**Re: Christina Lake Thermal Project Phase H and Eastern Expansion
Project Update and Supplemental Information Request 2 Responses
AER Application No. 1758947
EPEA Application No. 019-48522**

The purpose of this document is to provide responses to the Round 2 SIR package and provide updated information regarding the Project (Project Update). This document is organized into two parts as follows:

I:\CLIENTS\CENOVUS\14-1346-0011\mapping\MXD\C&R\SIR_Round2\ESRD_SIR_17_Figure_37_8.mxd

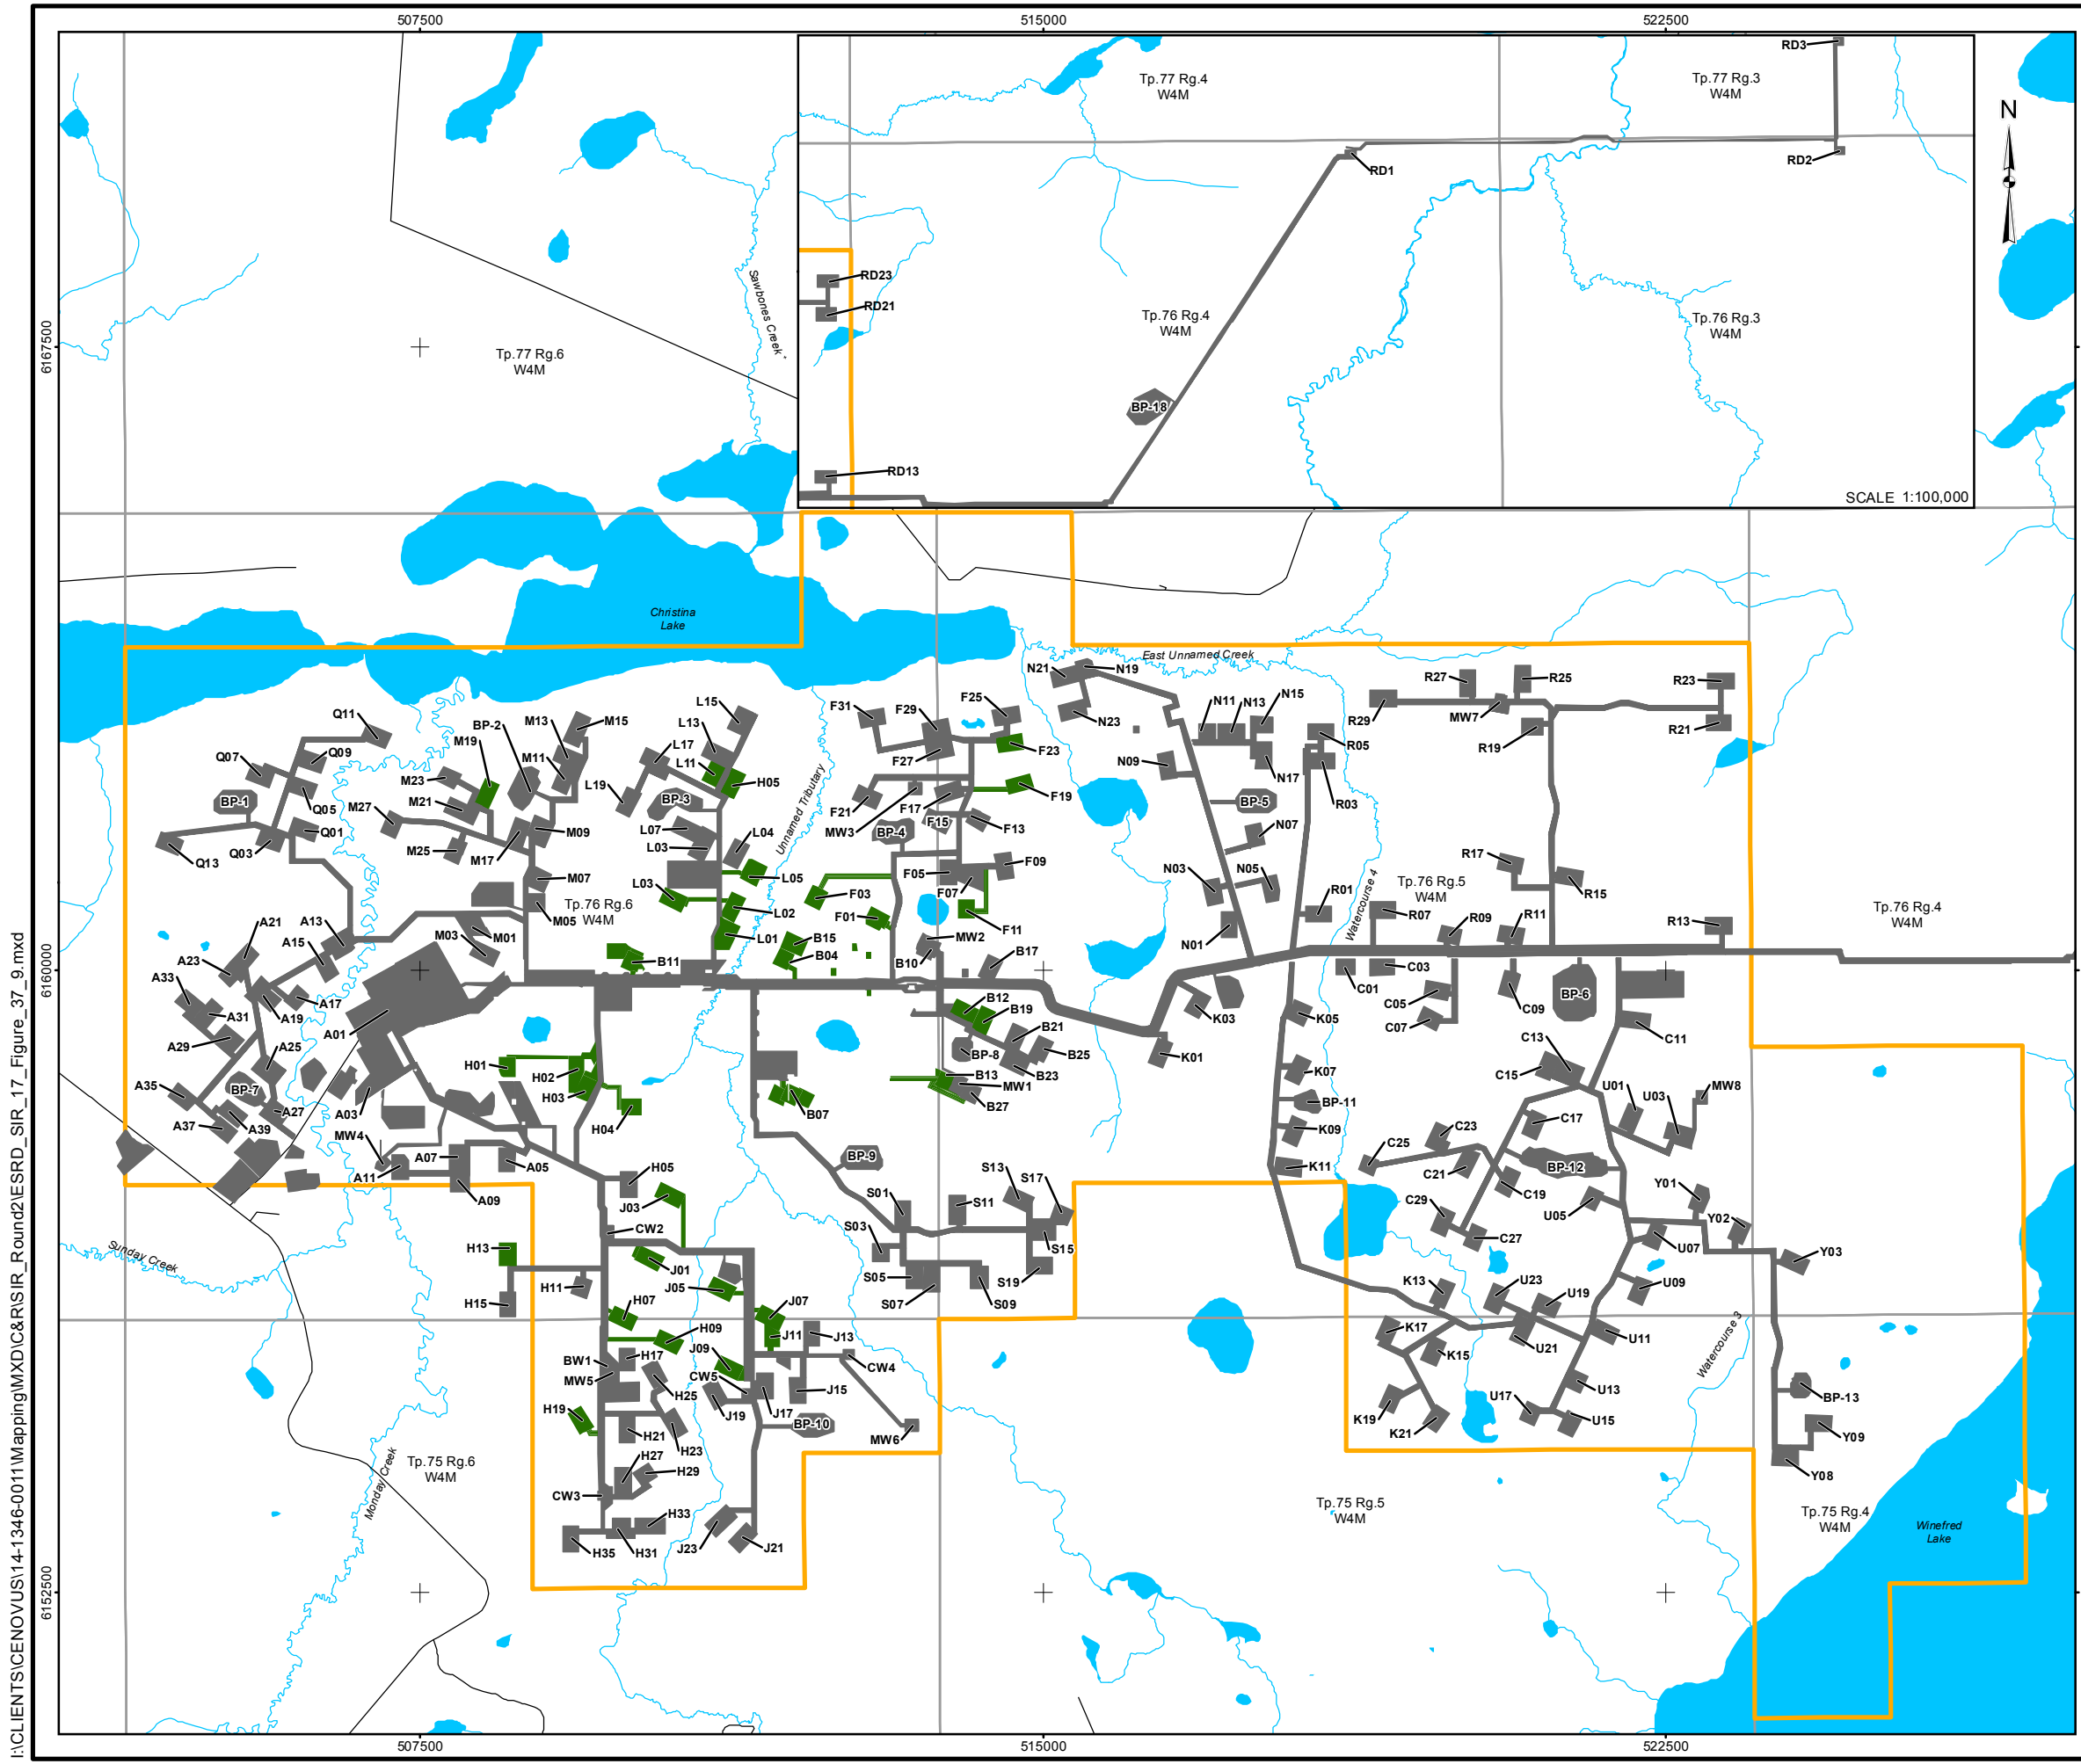
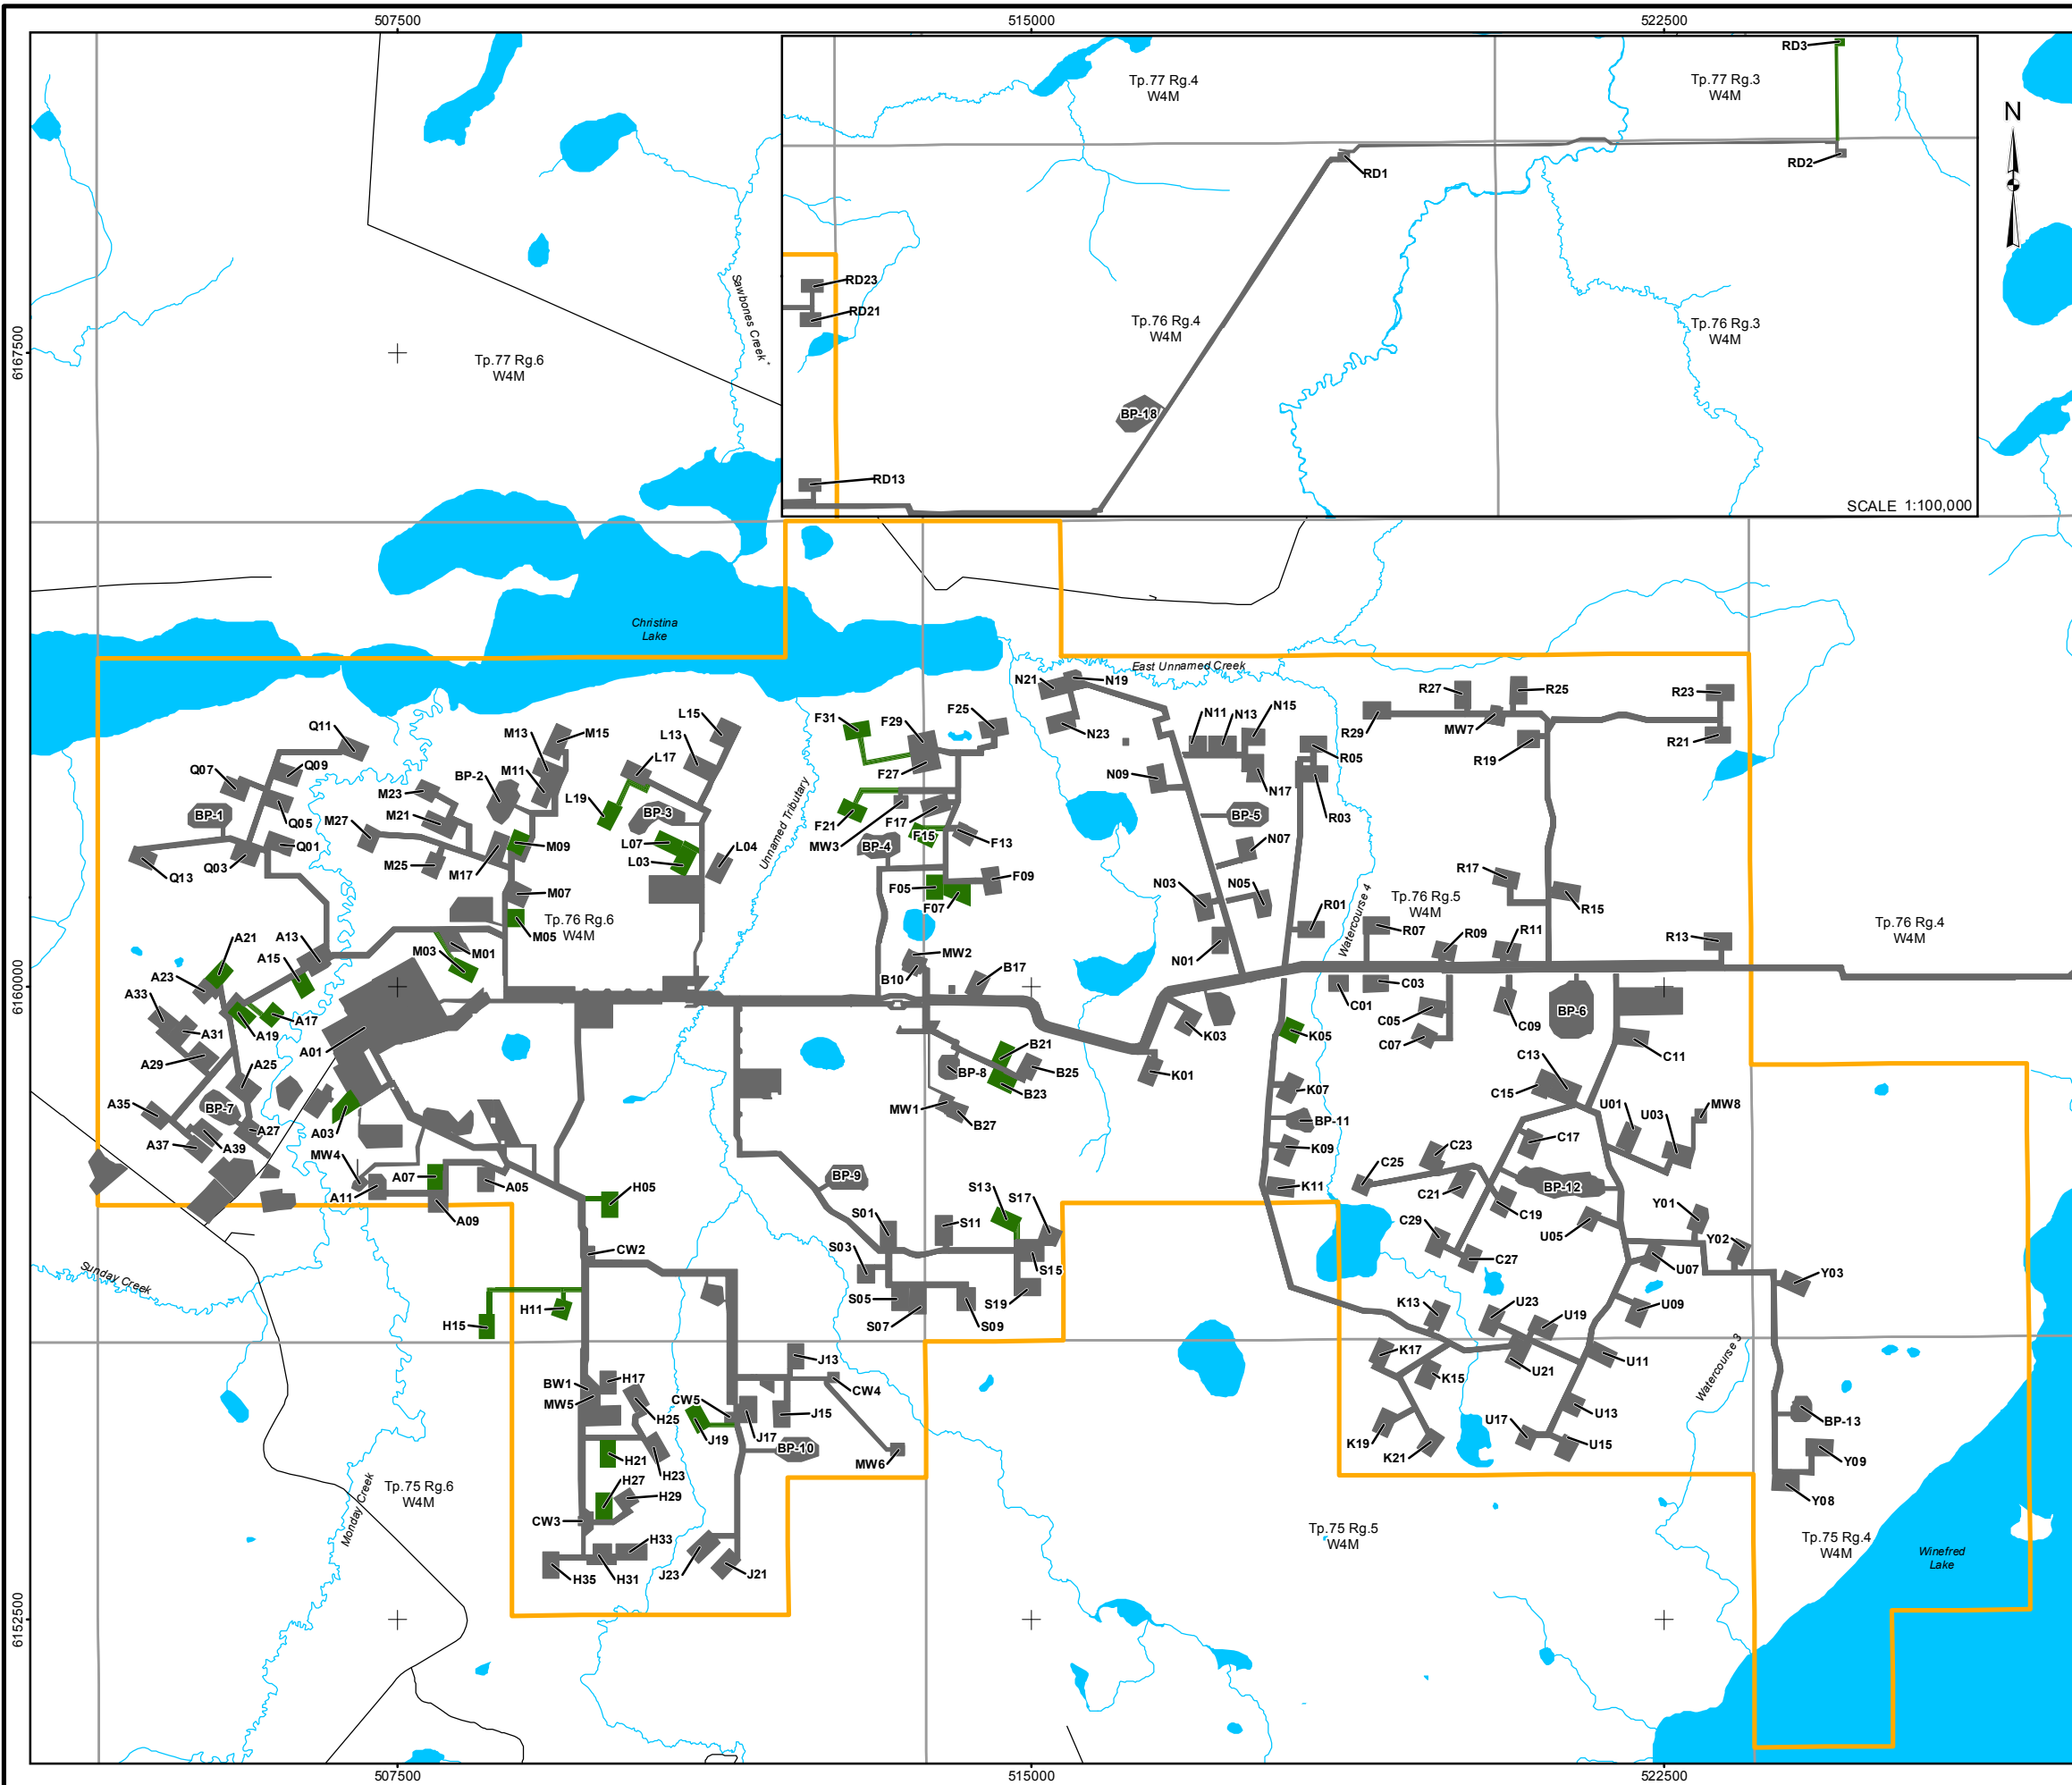
In Table 65-2, the column Unnamed (Monday) Creek appears to be mislabelled. All Figures in the SIR response 69 are mislabelled. In Figure 186-1, the sub-watershed is mislabelled.

Figures 69-1 to 69-13 from ESRD Round 1 SIR 69 have been revised and are presented as [Figures 37-1 to 37-13](#).
